# SUN VALLEY AREA DRAINAGE MASTER PLAN

## PROJECT ADMINISTRATION NOTEBOOK

December 2006

Figure 1. Example of poor subbasin delineation to hydrographic apex

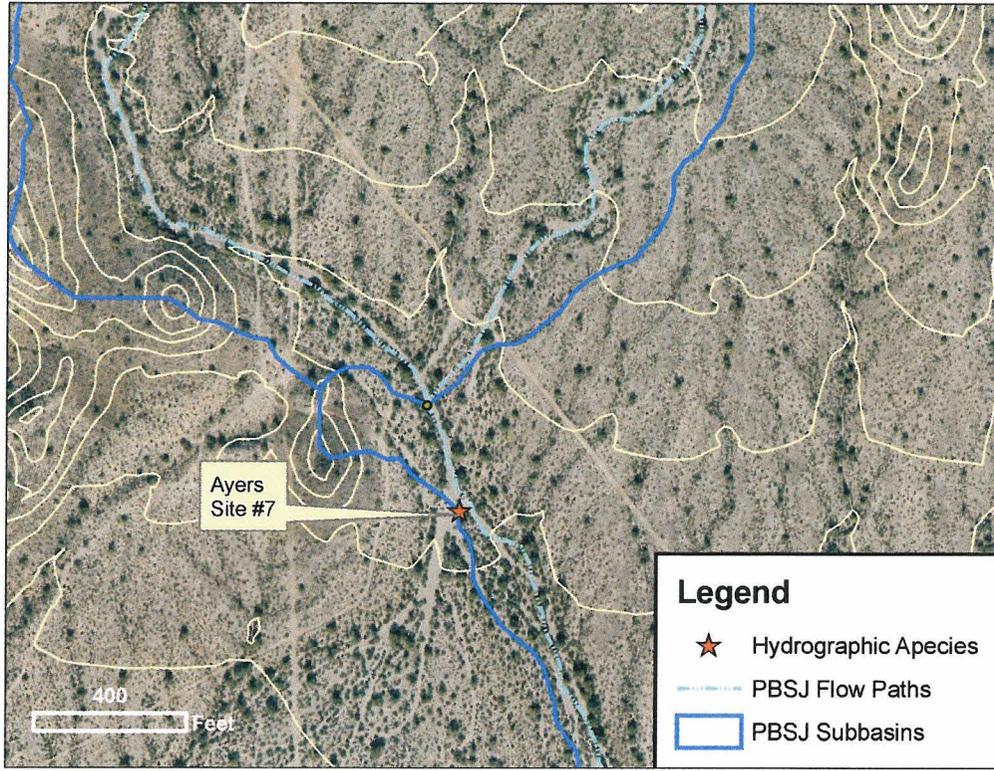
In general the delineation of watersheds leading to the identified hydrographic apieces is adequate. However, in a few instances subbasin delineations to apieces were slightly in error (Figure 1) or absent altogether (Figure 5).

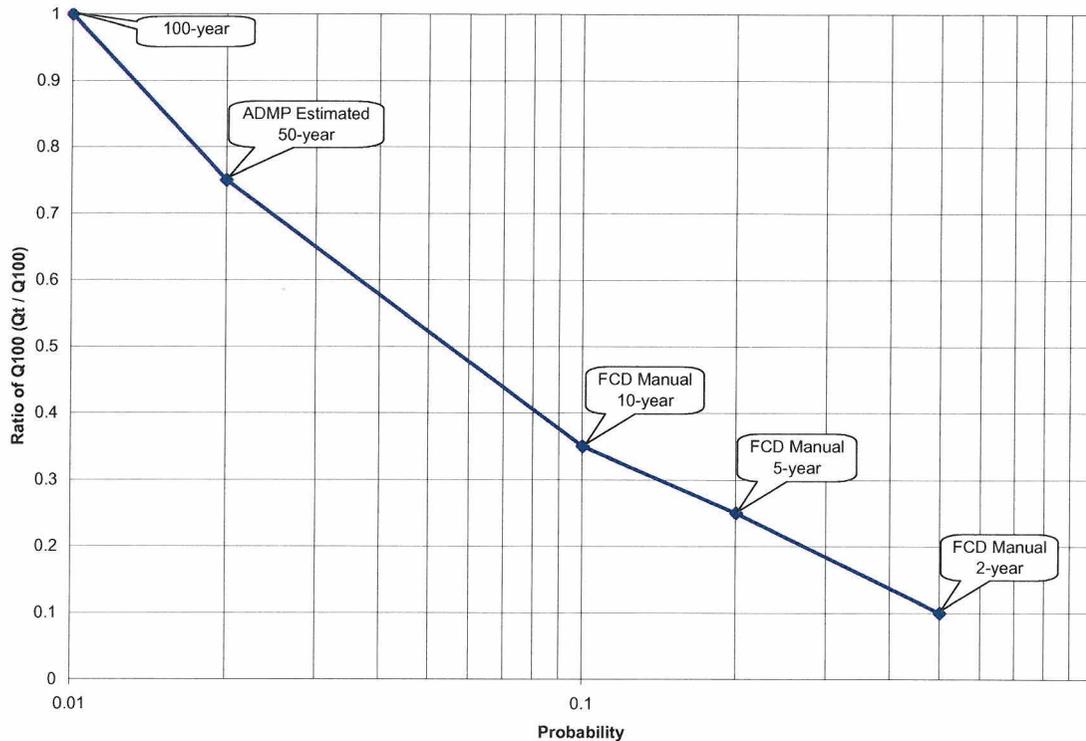
1. **FCD Comment (9/27/2006)** - In the Allowable Velocity worksheet, the FHWA Minimum Velocity should actually be the FHWA Maximum Permissible Velocity. Also, how were the FHWA values for soil cement, riprap, gabions, and concrete developed?

JEF Response (9/28/2006) - The label for FHWA Velocity will be changed to read as suggested. The values were arbitrarily set high in Step 2 to reflect "non-erodible" conditions. These material types are no longer being used in Step 3. However, we will modify the lookup table in the spreadsheet to contain the values shown in Table 6.3, pg. 6-15 of the 1996 FCD Hydraulics Manual.

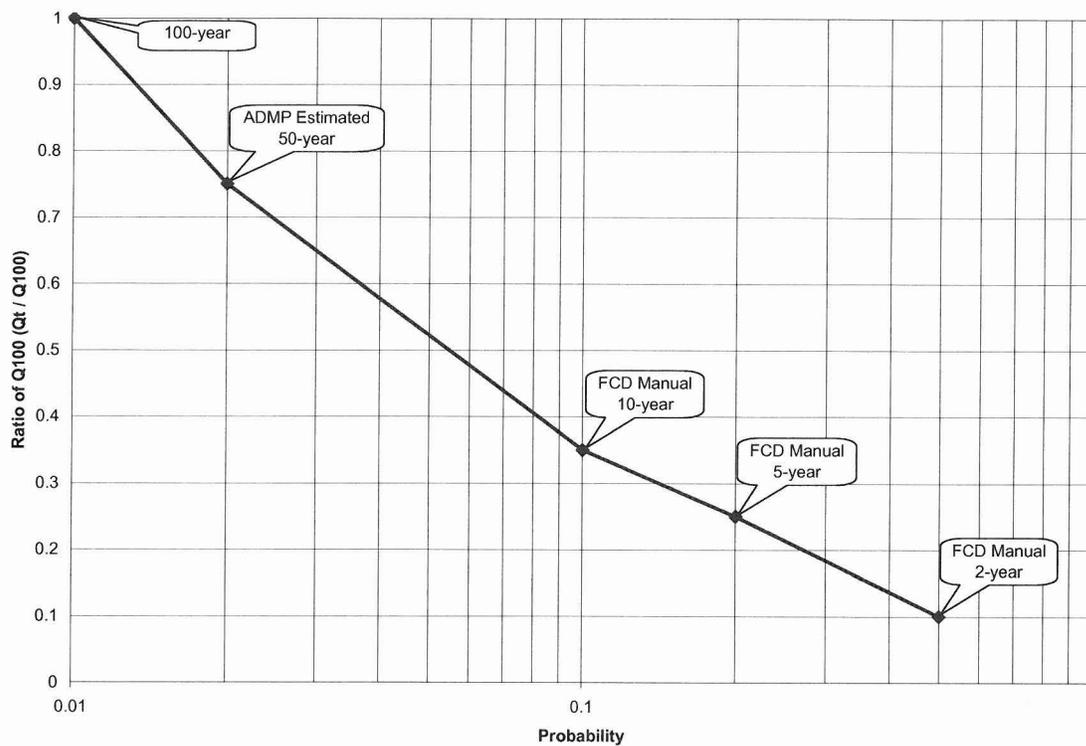
- 11. Table 6.1 in the FCD Hydrology Manual does not give a value for the 25 year and 50 year storm ratios, but the spreadsheet uses 0.55 and 0.75, respectively. How were these ratios developed?*

The following graph shows how the ADMP 50-year ratio was derived based on adding a point to a curve on a semi-log plot of the Q ratios vs. probability. The 25-year was not explicitly used in the ADMP.

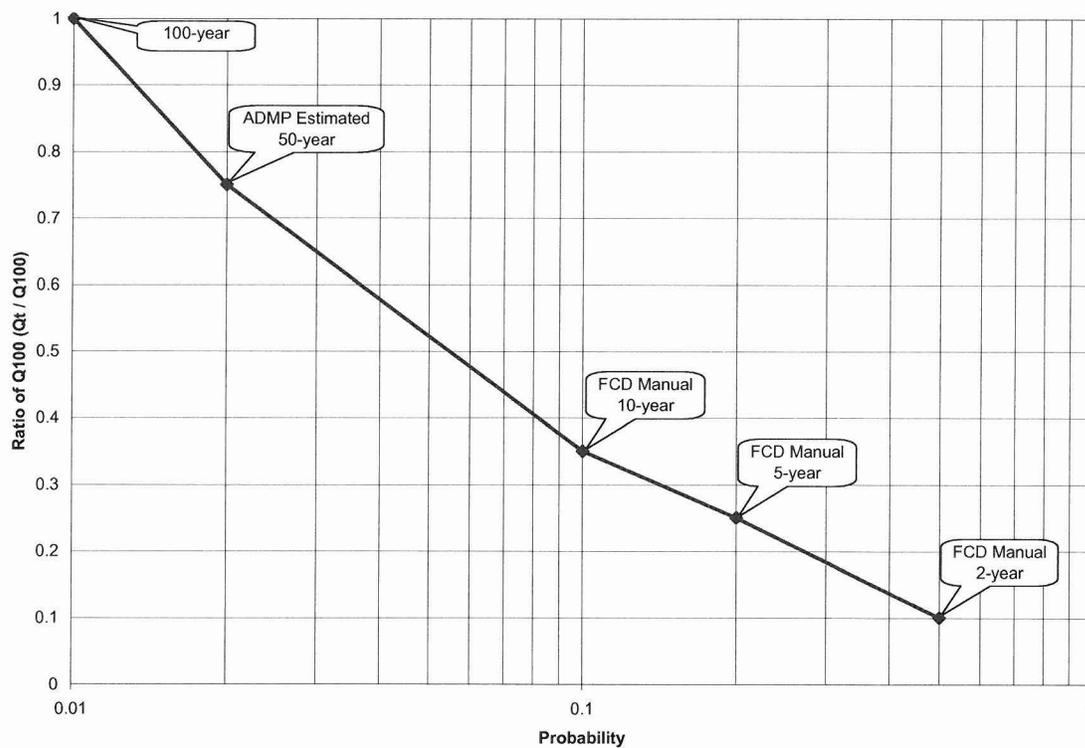
1. *FCD Comment (9/27/2006) - In the Allowable Velocity worksheet, the FHWA Minimum Velocity should actually be the FHWA Maximum Permissible Velocity. Also, how were the FHWA values for soil cement, riprap, gabions, and concrete developed?*

***FCD Response (10/16/2006) – The Allowable Velocity worksheet has not been corrected.***

*JEF Response (9/28/2006) - The label for FHWA Velocity will be changed to read as suggested. The values were arbitrarily set high in Step 2 to reflect "non-erodible" conditions. These material types are no longer being used in Step 3. However, we will modify the lookup table in the spreadsheet to contain the values shown in Table 6.3, pg. 6-15 of the 1996 FCD Hydraulics Manual.*
